**From:** Dyer, Miles [mdyer@JorgensenForge.com]  
**Sent:** Thursday, February 13, 2014 9:00 AM  
**To:** Sanga, Ravi; Timothy.L.Westscott@USCG.mil  
**Cc:** 'Ernst, William D' (william.d.ernst@boeing.com) (william.d.ernst@boeing.com)  
(william.d.ernst@boeing.com)  
**Subject:** Update Drawing  
**Attachments:** 2014-02-12-13092-S1\_1-OPT 1.pdf

**JORGENSEN FORGE FACILITY**  
**8531 EAST MARGINAL WAY**  
**SEATTLE, WA**

**OPTION 1**  
**SHORING PLAN**

OPTION 1 - SHORING PLAN

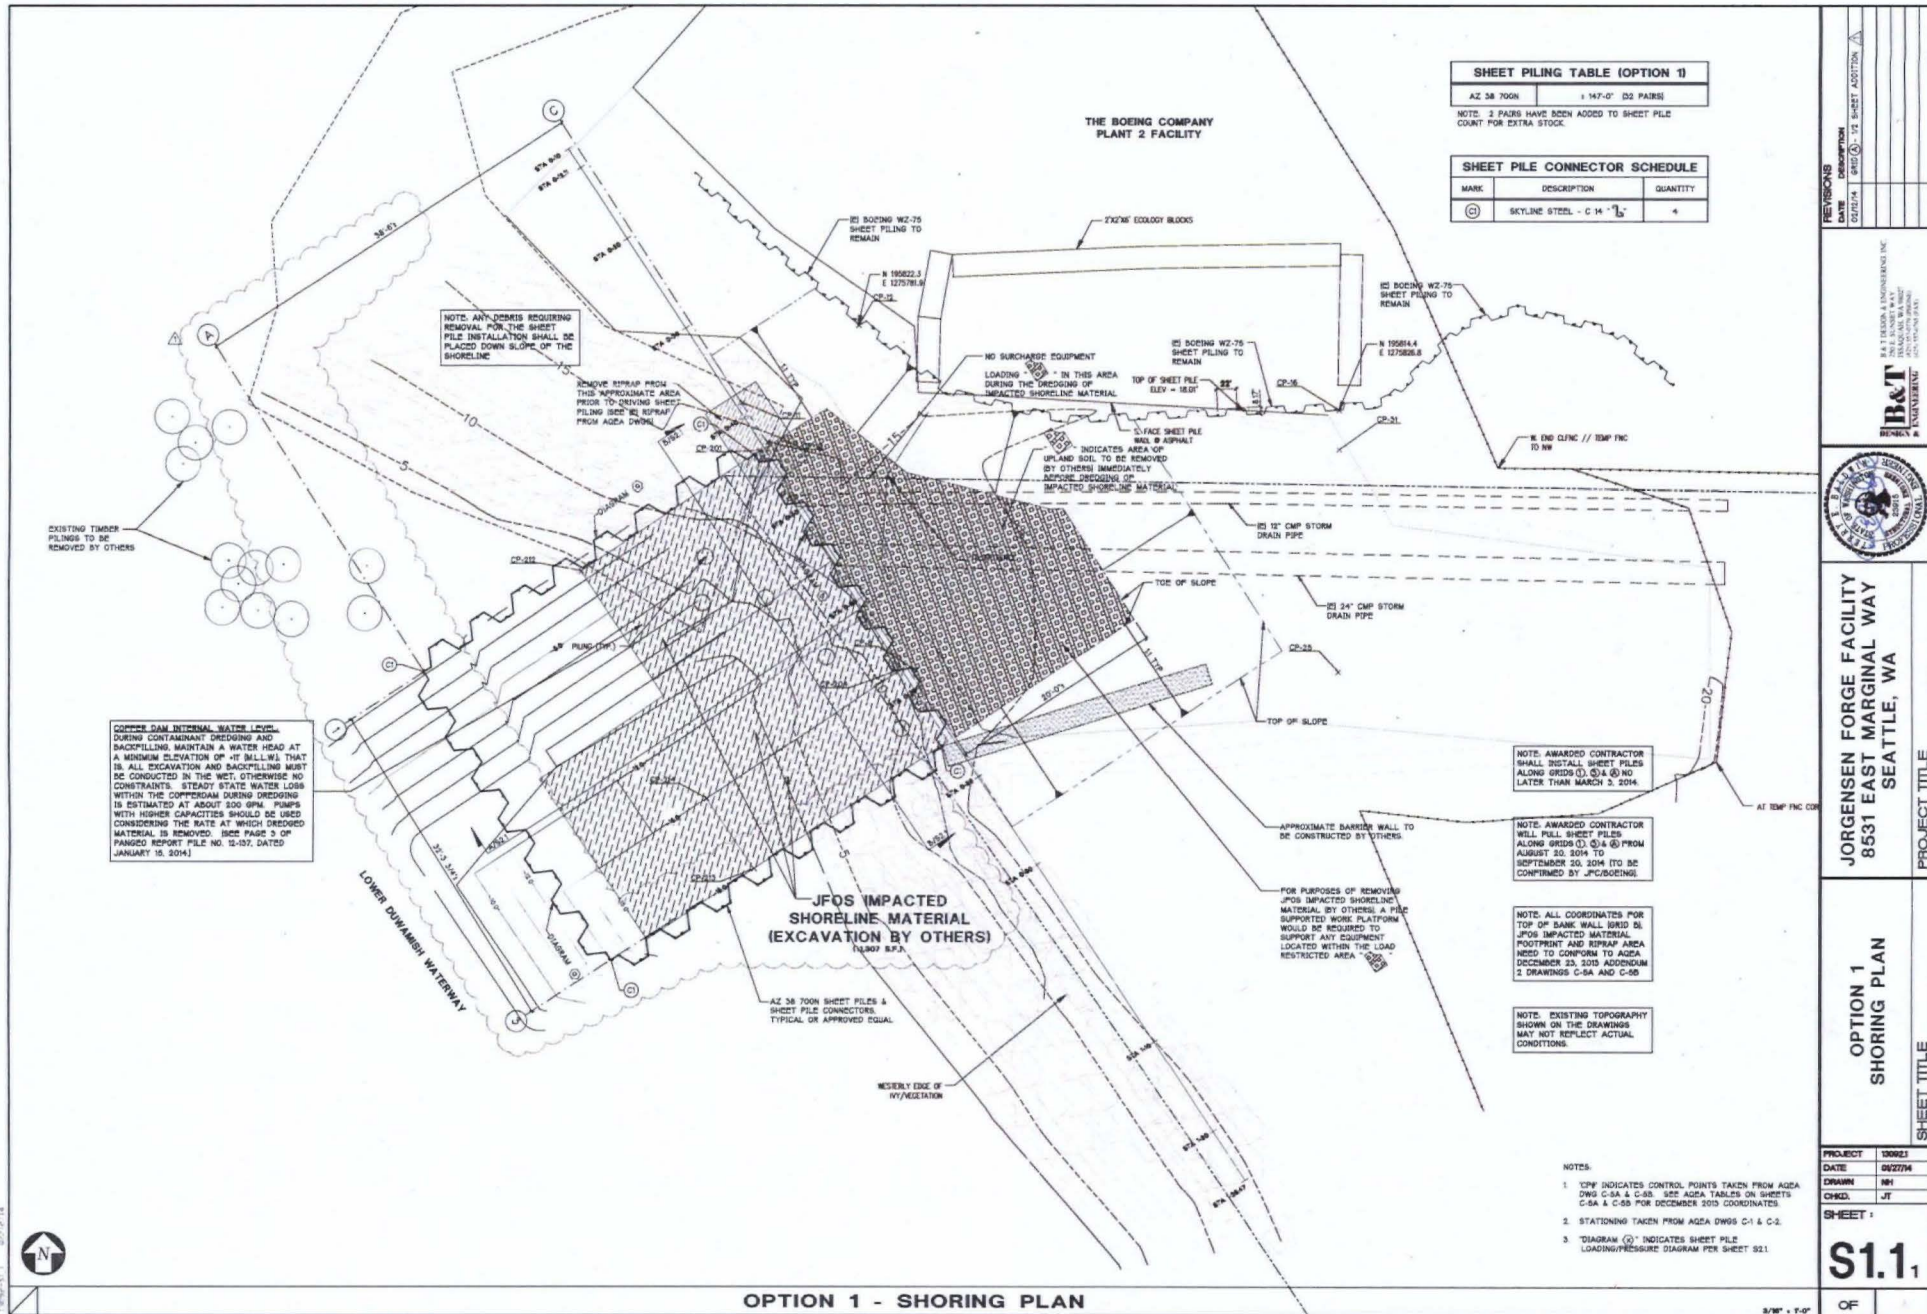
During the pre-construction meeting on 10 February, coffer dam corner designated as A-1 required a half sheet steel to be installed on the north-west wall which creates the corner to the wall running in a north-south direction.

A full sheet steel section will be used instead of the half sheet on the north-west wall. The full sheet installation will extend the length of the north wall approximately 10-12 inches. This area, inside the coffer dam; is annotated as an area where dredging is not required. There is no impact for future work to be performed during August 2014.
